Re: Minor Project Refinement No. 7 for the TL 6975 San Marcos to Escondido Project.

ATTACHMENT A
MPR-7 Form

TL6975 San Marcos to Escondido 69 kV Project CPUC Minor Project Refinement Form

ATTACHMENT B
MPR-7 Figure

MPR-7 Figure 1
Mapbook

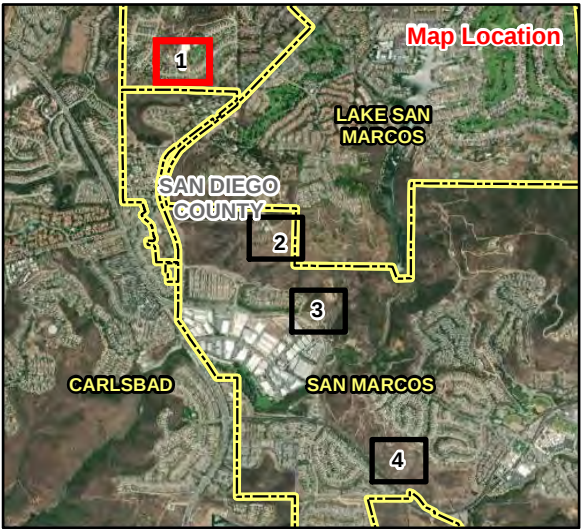
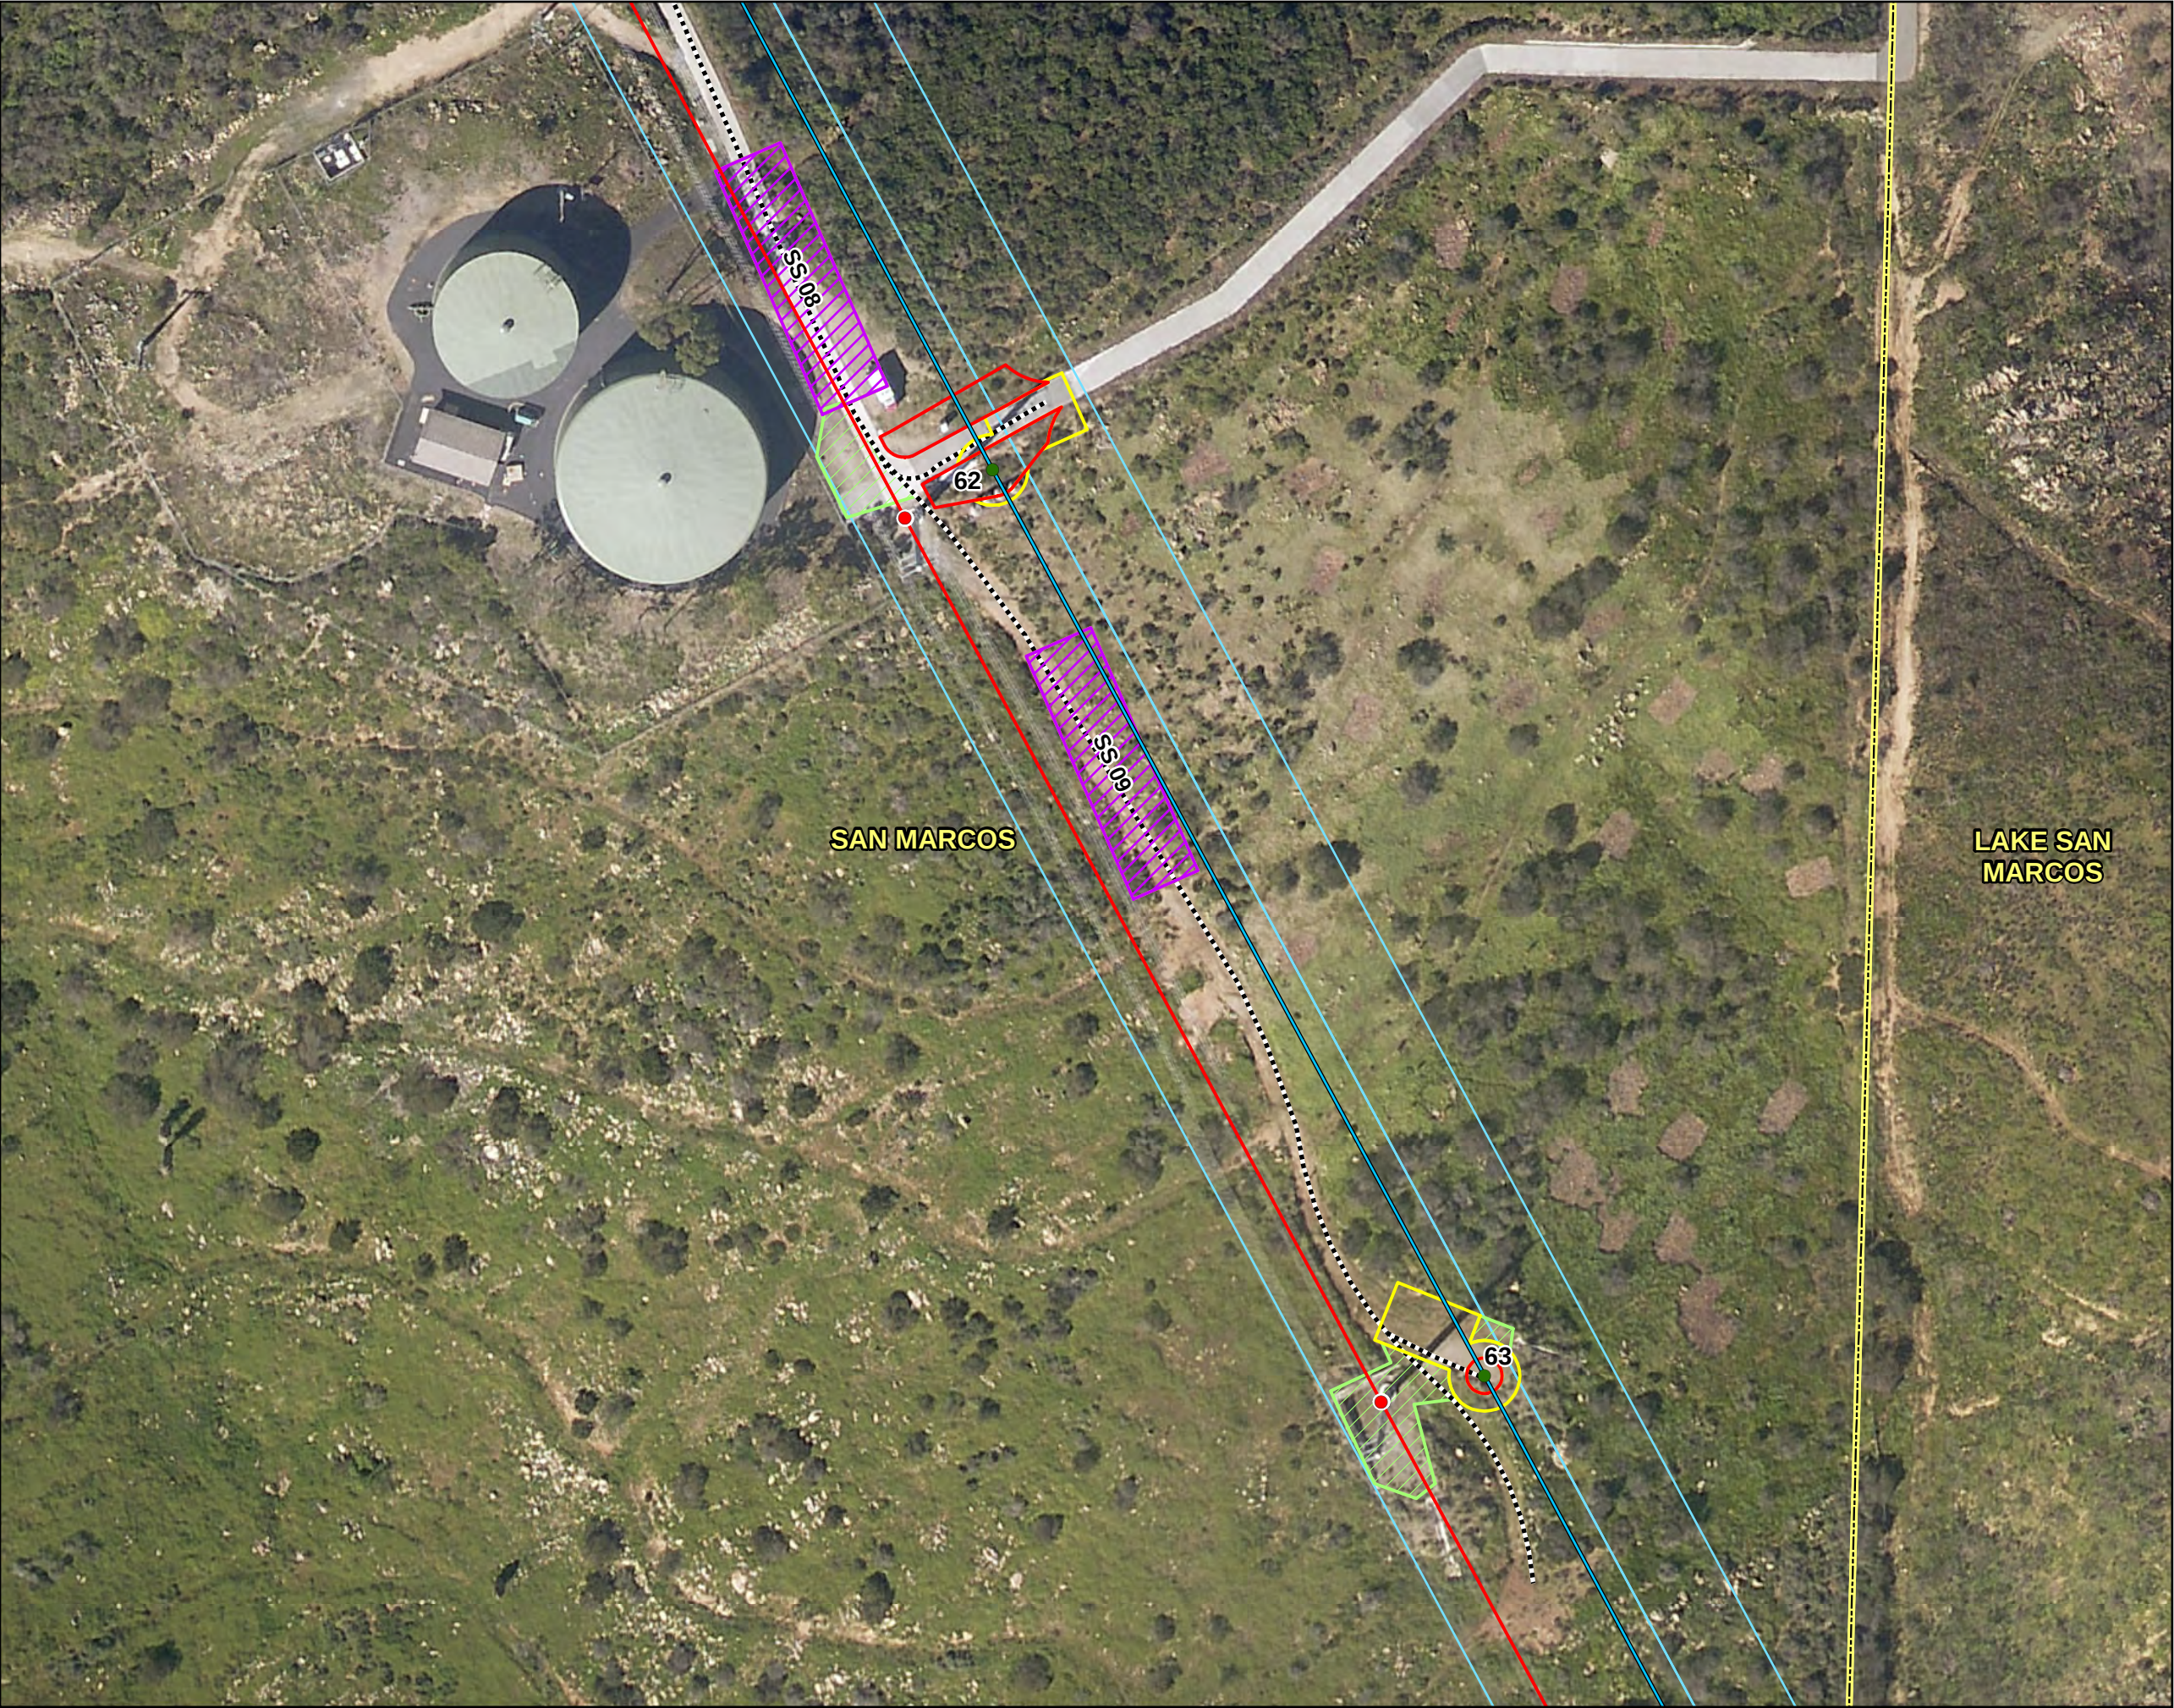
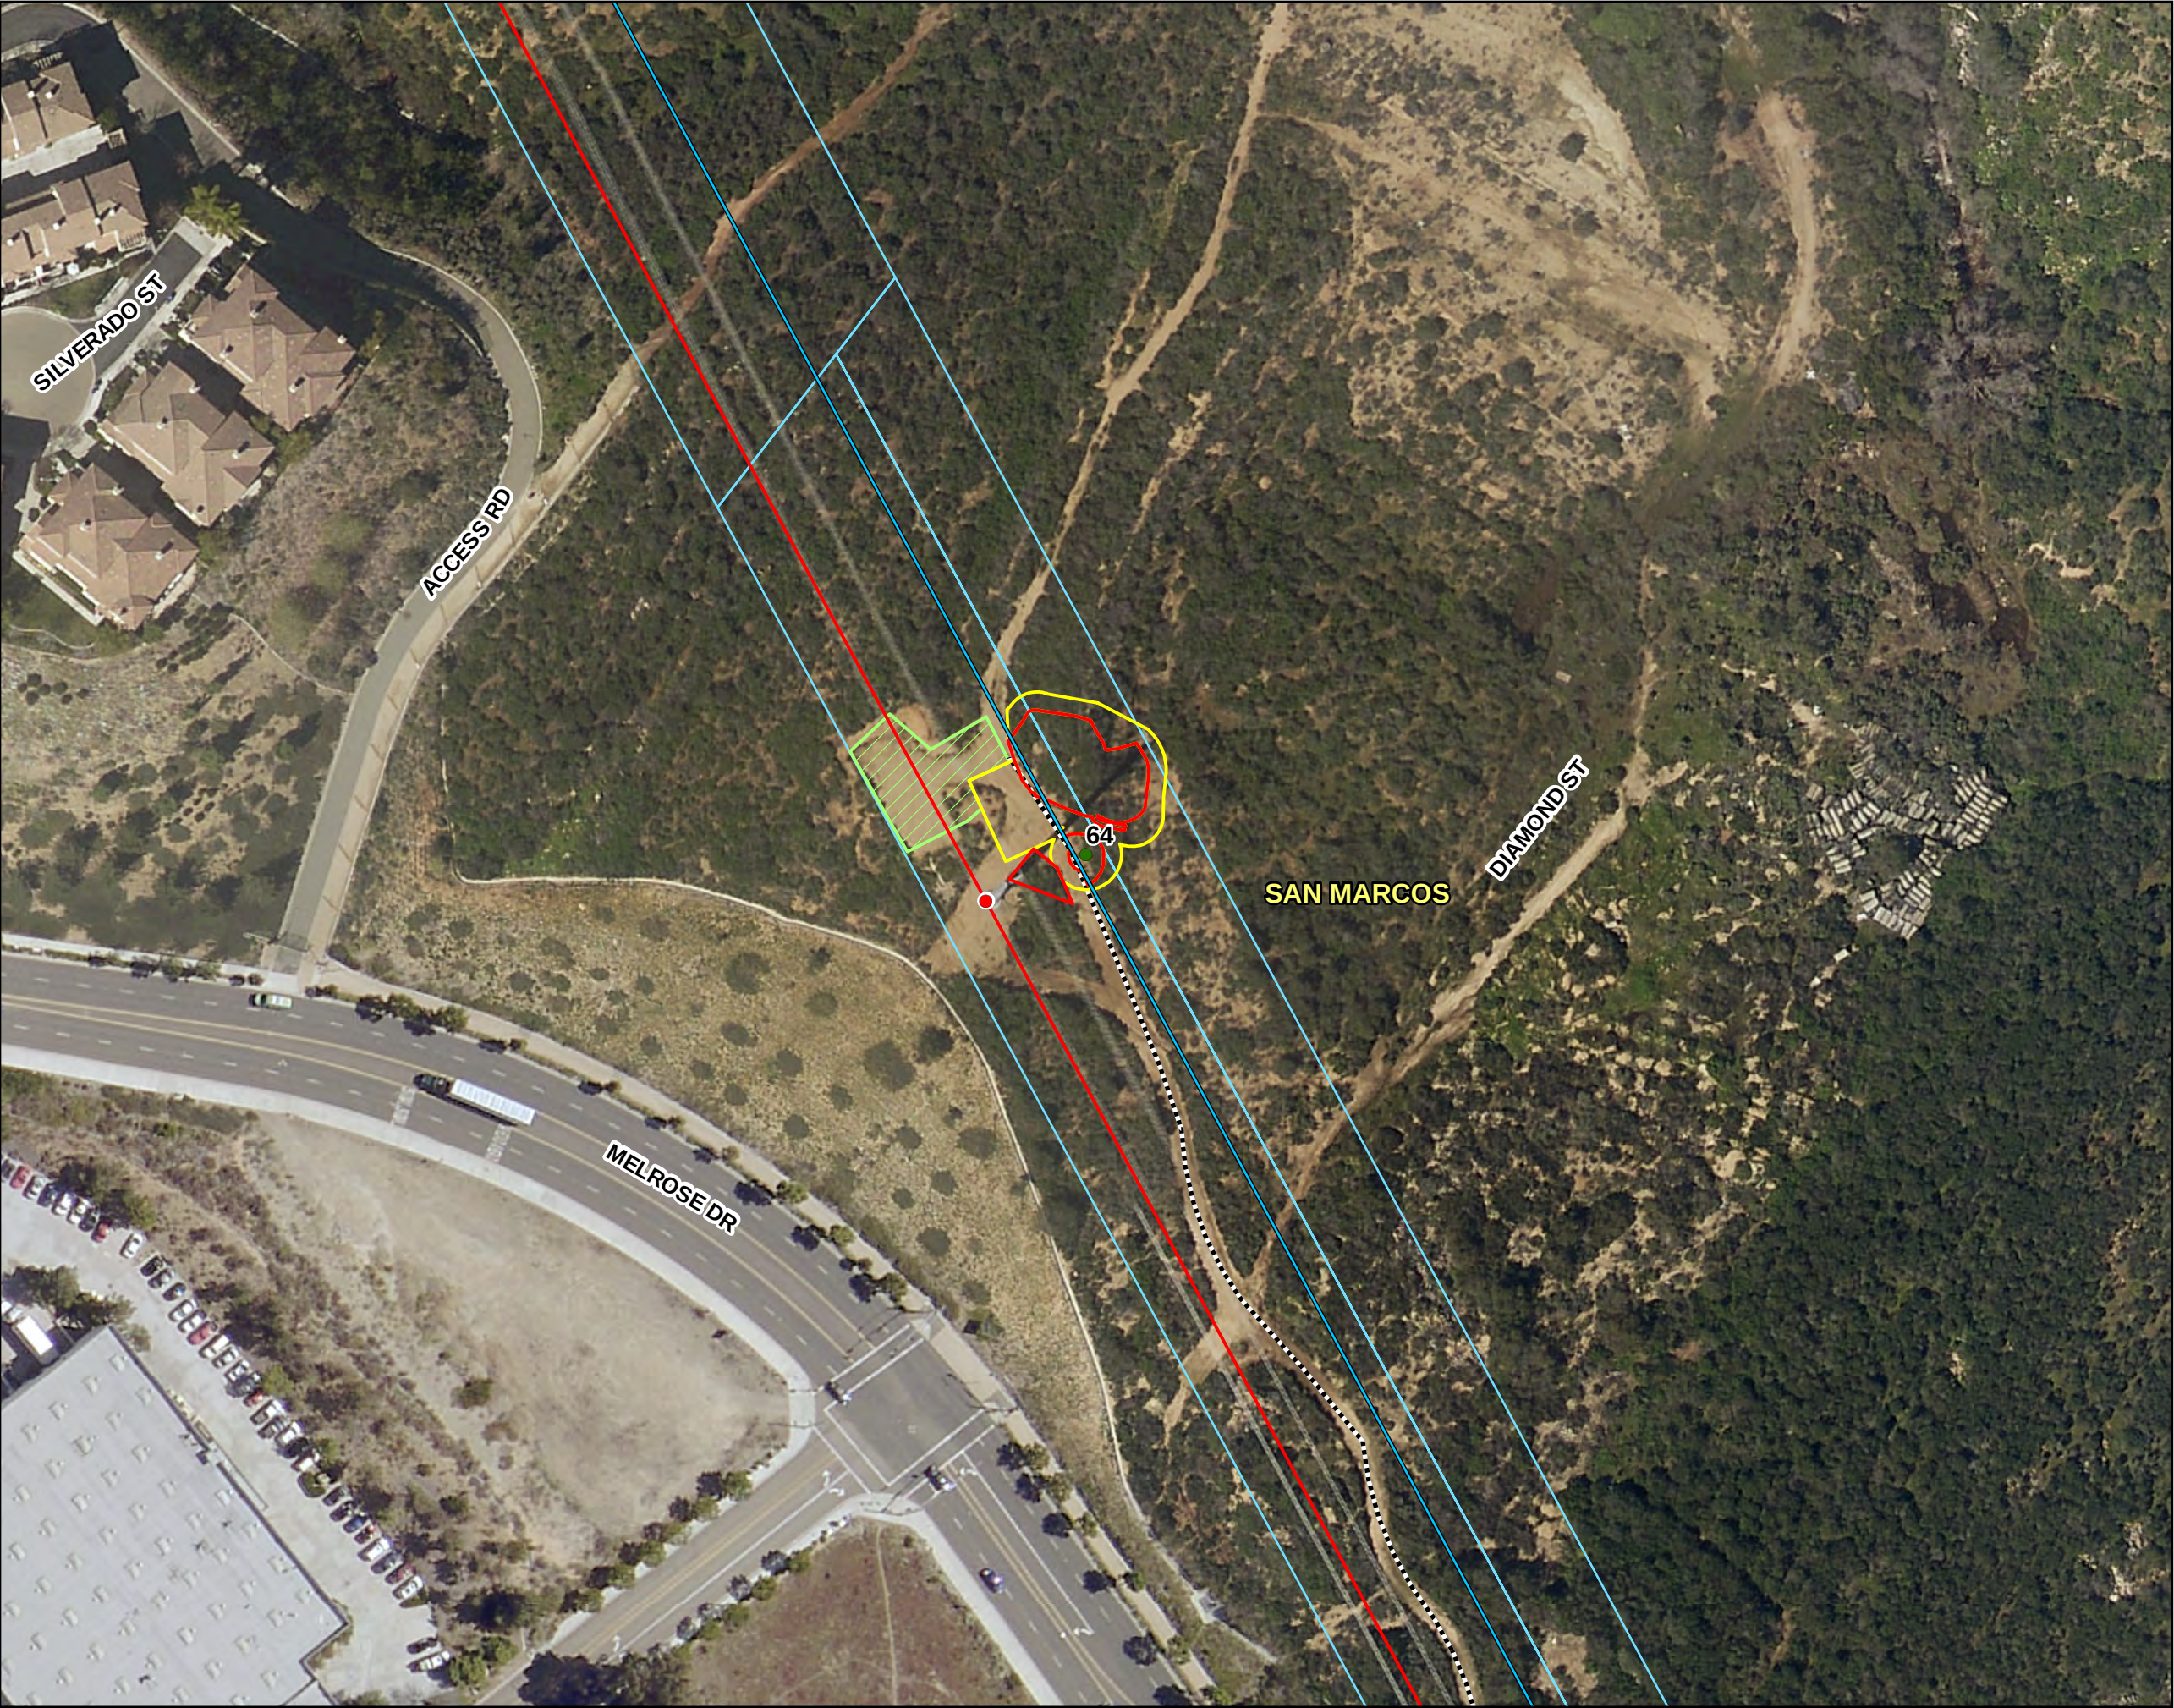
San Diego Gas and Electric (SDG&E) is requesting approval of MPR-7 for five additional temporary work areas (WA) at Locations 57, 62, 63, 64 and 69 to facilitate pole installation activities in Segment 2 of the TL6975 San Marcos to Escondido Project (Project). The additional work areas will be used for temporary staging of materials and equipment associated with the

Following the field constructability review, the construction contractor identified the need to utilize additional space for pier foundation pole installation activities at Locations 57, 62, 63, 64 and 69. In an effort to maximize available space to safely and efficiently perform the pier foundation pole installations while minimizing additional impacts resulting from the Project, MPR-7 is proposing the use of existing maintenance pads and previously disturbed areas to support this work (see **Attachment C, MPR-7 Site Photographs**). The MPR-7 additional work areas would be utilized for temporary staging of materials and equipment such as drill support equipment, water trucks for dust control, rebar cages, etc. In addition, the MPR-7 work areas can be used for safely maneuvering vehicles during pier foundation pole installation activities, such as turn-around areas for cement trucks.
